NUREG/CR-3235  
SAND82-1557  
WH

TECHNICAL ASSISTANCE FOR REGULATORY DEVELOPMENT:  
REVIEW AND EVALUATION OF THE EPA STANDARD 40CFR191  
FOR DISPOSAL OF HIGH-LEVEL WASTE

EXECUTIVE SUMMARY

Figure 1: Health effects associated with one curie release for the ingestion pathways.

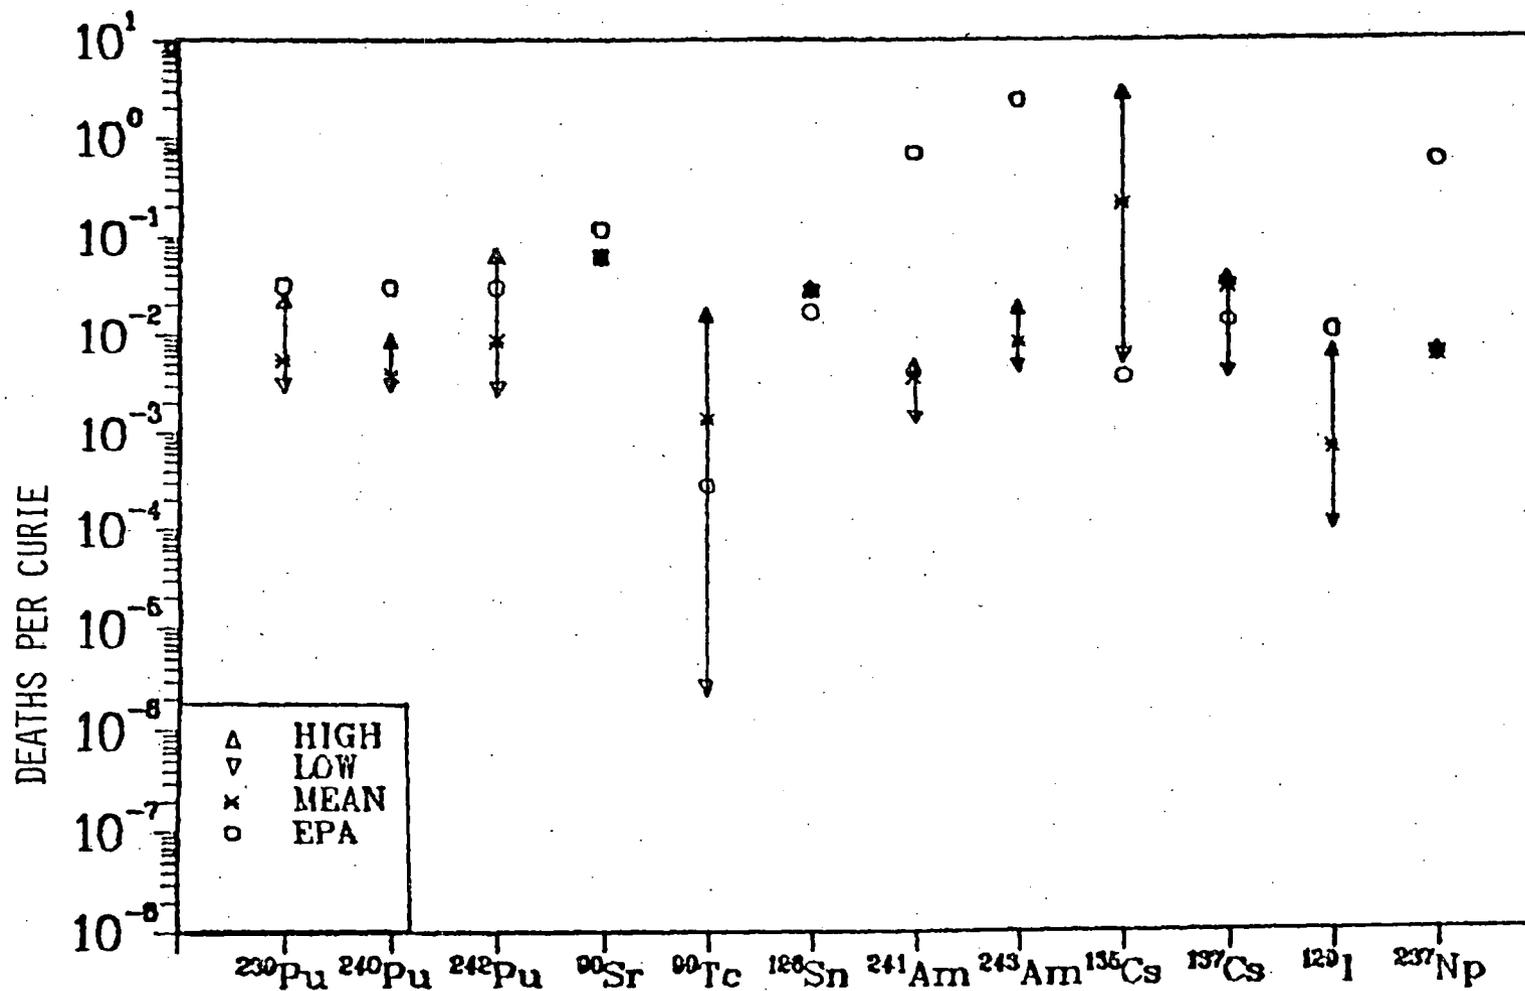
surface water and soil compartments. A sample comparison with the EPA calculation is presented in Figure 1, which shows the health effects associated with one curie of a given radionuclide when the ingestion pathways are considered.

Figure 8. CCDF for Scenario 5, Direct Hit Scenario. (The Shaded Area Indicates Violation of the Draft EPA Standard.)

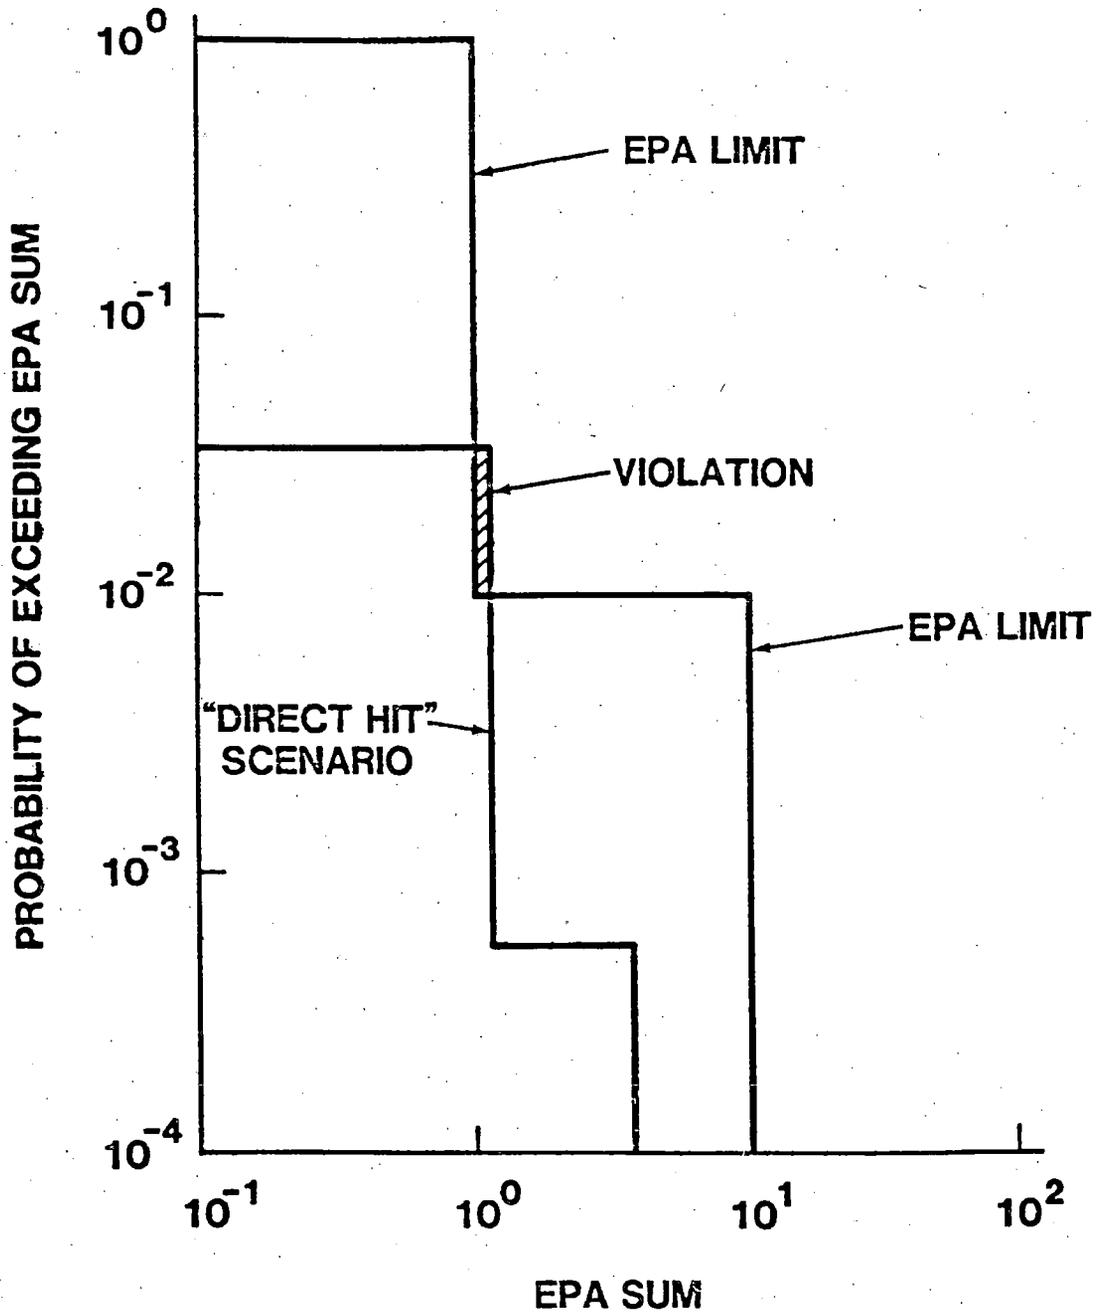
Equation (13) was evaluated to give probability,  $P(N)$ , of the N-hit scenario. Equation (15) gives the time,  $t_j$ , for each of the N direct hits. Values from Table 10 were interpolated at  $t_j$  to give values of the EPA Sum, as illustrated in Equation (16). These results are presented in Table 11 and Figure 8. As can be seen in Figure 8, this scenario, when considered by itself, is in slight violation of the draft EPA Standard.

Figure 9. CCDF for the Brine Pocket Penetration Scenario. (The Shaded Areas Indicate Violation of the Draft EPA Standard.)

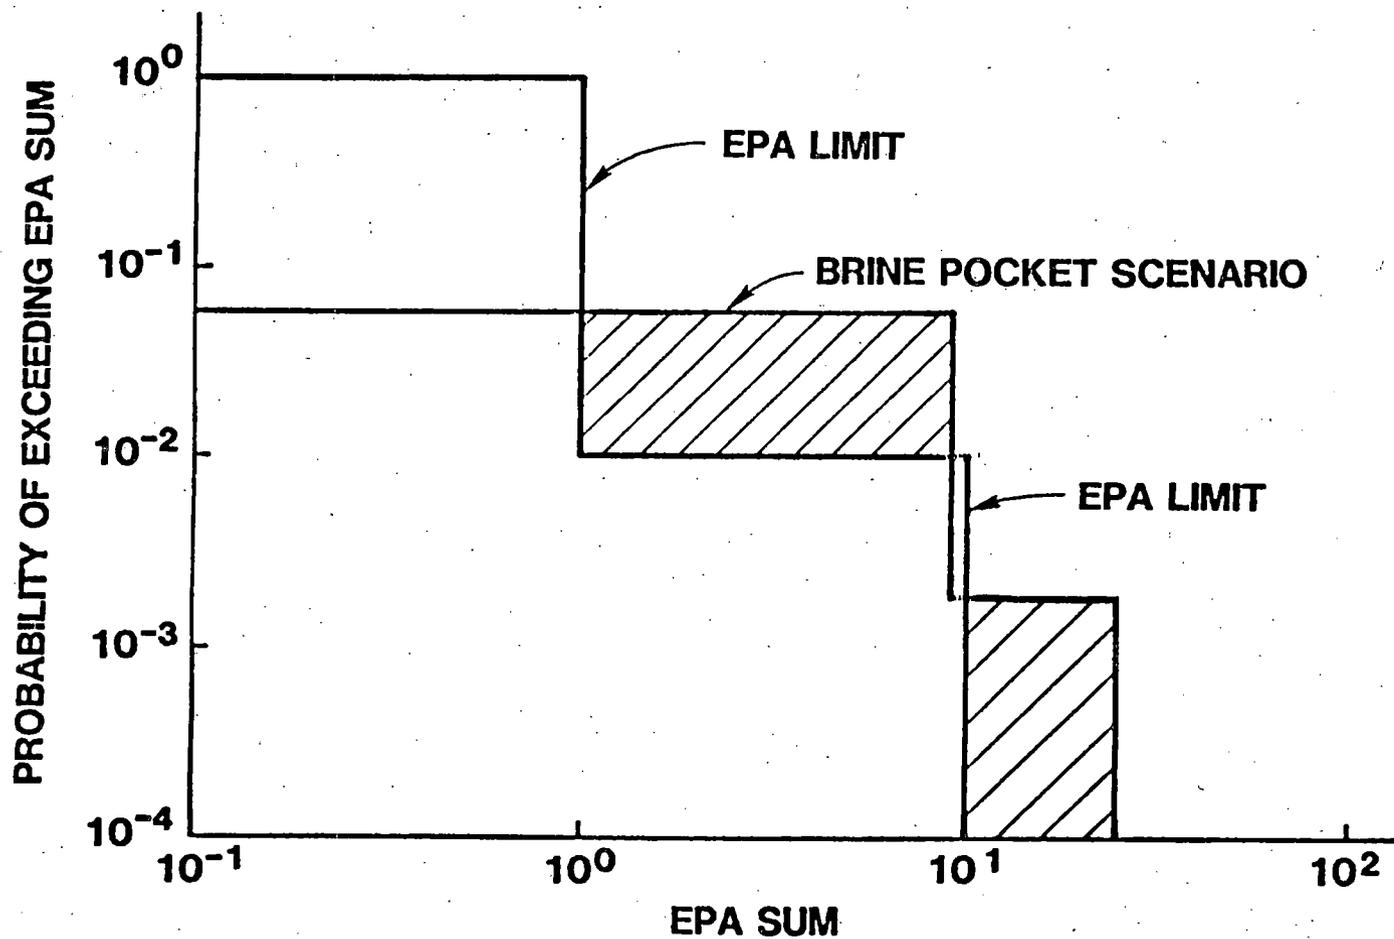
Equation (13) was used with  $P_{hit} = .02$  to evaluate probabilities,  $P(N)$ , of  $N$  brine pocket penetrations that release radionuclides. Equation (15) was used to evaluate  $t_j$  and the EPA Sum was evaluated according to Equation (17). Table 10 values were interpolated to give values at  $t_j$ . These results are tabulated in Table 12 and the resulting CCDF is presented in Figure 9. As can be seen from Figure 9, this scenario, when considered by itself, violates the draft EPA Standard.

Figure 5.3.

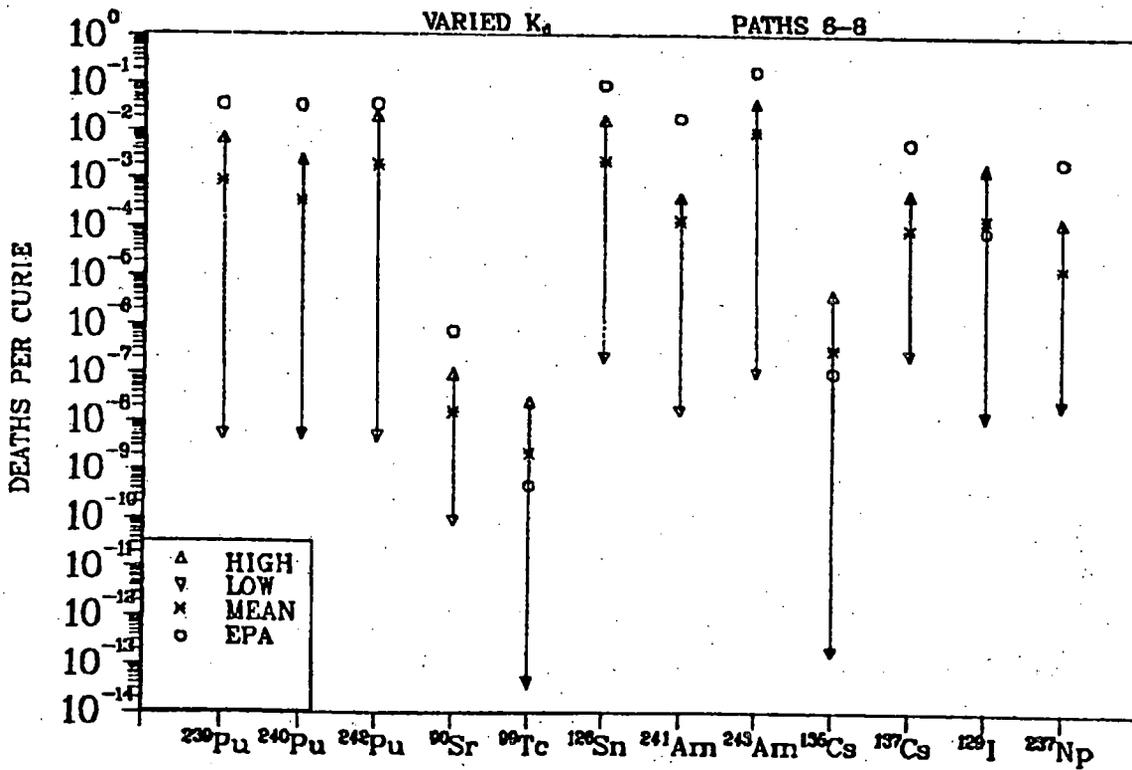
Of note are the EPA values for  $^{241}\text{Am}$ ,  $^{243}\text{Am}$  and  $^{237}\text{Np}$  for pathways 1-5 (Figure 5.3). The results of this analysis for  $^{241}\text{Am}$  and  $^{243}\text{Am}$  indicate that the release limits for these radionuclides may be overly conservative and may warrant a reexamination by the EPA. Also, the EPA release limit for  $^{135}\text{Cs}$  would appear not to be restrictive enough from the results of this analysis and again may warrant some reconsideration.
